Subject: DA2023/0868 response

The Planning Officer, DA 2023/0868

Joseph & Jayne Hauser 31 Hay Street, Collaroy 23 July, 2023

Photo 2: Parking in Hay Street looking north towards location of proposed development on right

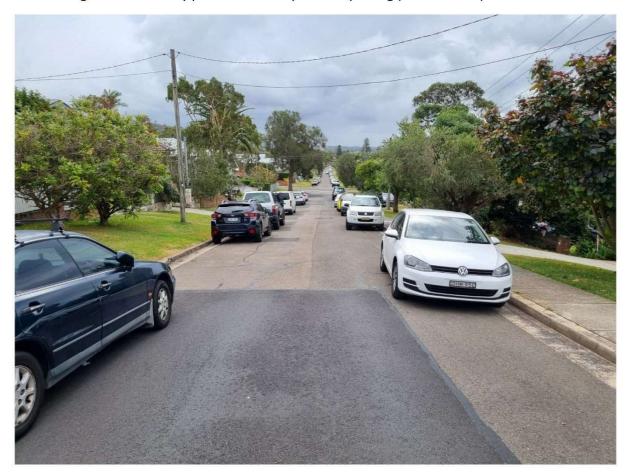
The basement parking is difficult to navigate for drivers with varying skill. Then the default will be to park in Hay Street or Anzac Avenue (clearways on Pittwater Road regulate parking durations). The surrounding streets currently present limited spaces for parking (refer Photo 2).

The parking of vehicles is a vexed issue as it stands now. Hay Street is <u>not</u> wide enough (only 7.2m kerb face to kerb face) for parked cars either side of the street and <u>two cars passing</u>. The waste collection trucks struggle to negotiate the street and finding places for bin collection dedicated to Fridays is awkward (refer Photo 3). In addition, Hay Street is identified as a <u>bicycle route alternative</u> to Pittwater Road.
